Find the drum; keep the grid

Retain useful controls and fast routes. A change must earn its tradeoff in actual use.

NEW R3 / DESIGN MODEL

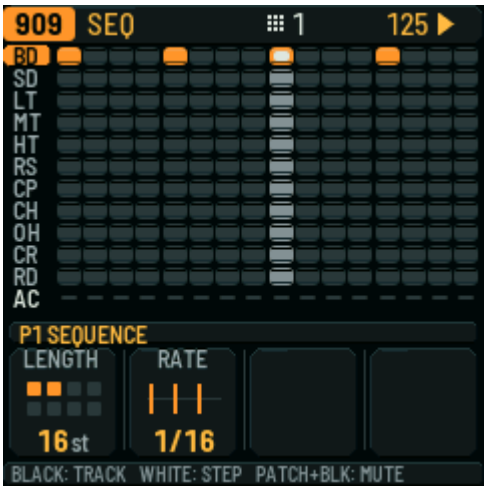
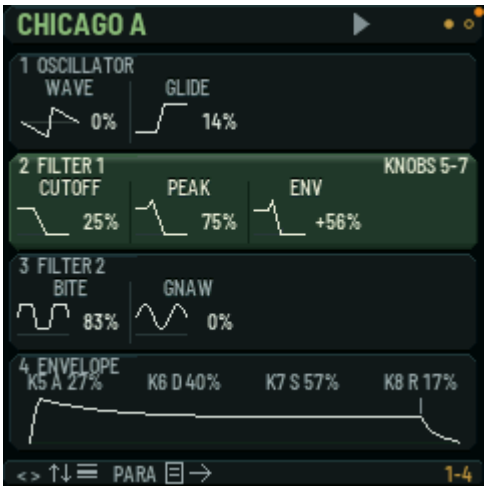
Change New percussion pictures replace row abbreviations. The selected picture/full name uses only the former unmapped K7/K8 display area; both knobs remain unmapped.

Access Running snare selection: G#3, then pad 4 toggles step 5. Length/rate still need one direct K5/K6 turn. No extra page or confirmation.

Tradeoff Tiny-symbol and 808 variant recognition is unqualified. The large picture must not imply a new editable control. Retain baseline if actual-use benefit does not outweigh that cost.

Keep All 11 tracks plus accent, 16 columns, LENGTH/RATE, black-key selection, white/pad step entry and PATCH+black mute.

Keep the sound overview

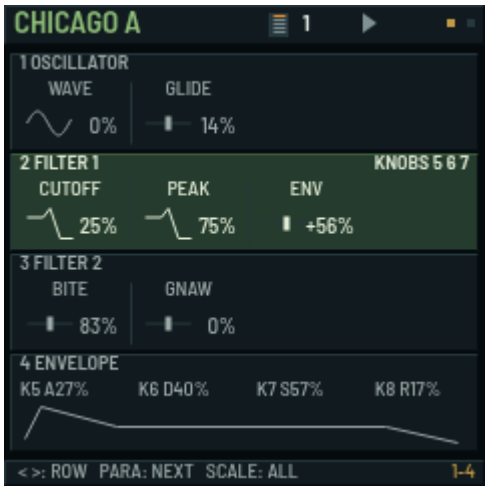
Withdraw The rejected single-group focus replacement. Chicago 8, Miami 6, Juno 5, Drone 3 page cycles include SOUND.

Access Known OSC memory from SEQ: PARA → K2+ → K5 =3 logical gestures. Deep list: SCALE → K2+ → K2+ → K3 → PATCH =5. R3 retains both routes.

Tradeoff No improvement over current parameter navigation is claimed. This is deliberate retention. Other values are illustrative fixtures; native DSP wave-cache and typography parity are not established.

Keep Four neighboring parameter groups, one four-column physical mapping, existing glyph/readout/ADSR families, reverse wrap and deep list.
